## Market Change Request

Number		Title	Priority
<b>MCR</b>	<b>0091</b>	Amendments to MPD 28 1.2 (New Technical MPRN) to satisfy new requirements for SEM Implementation	<i>HIGH</i>

#### Detailed changes to MPD 28 (1.2) – New Technical MPRN :-

## 2. ARIS Process Flow Diagram: Supporting Text

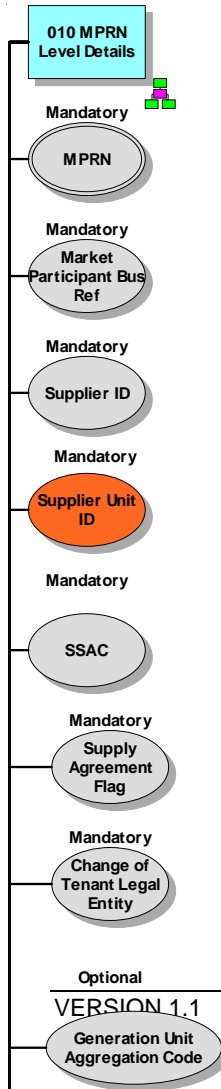
Details of the process where the Description has changed are listed below :-

Name	Validate Registration
Description	<p>MRSO will validate the registration in accordance with the applicable validation rules and advise the Supplier of the outcome. Failure of the following validations will cause the registration to be rejected.</p> <ul style="list-style-type: none"> <li>• The Supplier must have provided all mandatory information</li> <li>• The TMPRN must have been assigned and is not terminated</li> <li>• The Supplier ID is a valid one and the Supplier has a UoS agreement.</li> <li>• The Supplier must be entitled to register a Connection Point under the legislation and in accordance with the Trading and Settlement Code.</li> <li>• The Supplier warrants that a supply agreement exists with the customer at the Connection being registered.</li> <li>• The TMPRN must be for a single unmetered site (i.e not associated with a Group MPRN)</li> <li>• The Supplier must provide a Supplier Unit that is valid for the Supplier.</li> <li>• The Supplier Unit must not be Trading Site Supplier Unit.</li> <li>• The Supplier must provide a sub-aggregation code (SSAC) that is valid for the Supplier Code Unit and for the Settlement Class.</li> <li>• Failure of the following validation will cause the registration to be rejected unless the DSO approves the new information: <ul style="list-style-type: none"> <li>• Connection Point Address advised by Supplier is materially inconsistent with Connection Point Address known to MRSO. DSO may accept or reject the new address submitted by the Supplier.</li> </ul> </li> </ul>

3.1 MM010

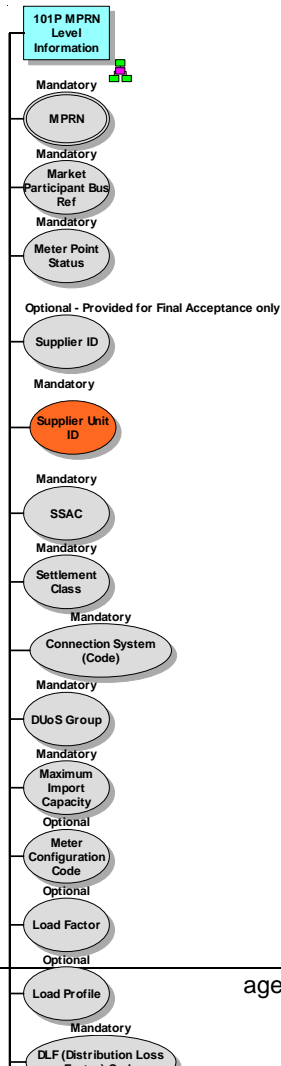
“Supplier Unit ID” will be added to “MPRN Level Details” above “SSAC” in the 101, 101P and 101R Market Messages and Generation Unit ID removed from the 010, as follows:-
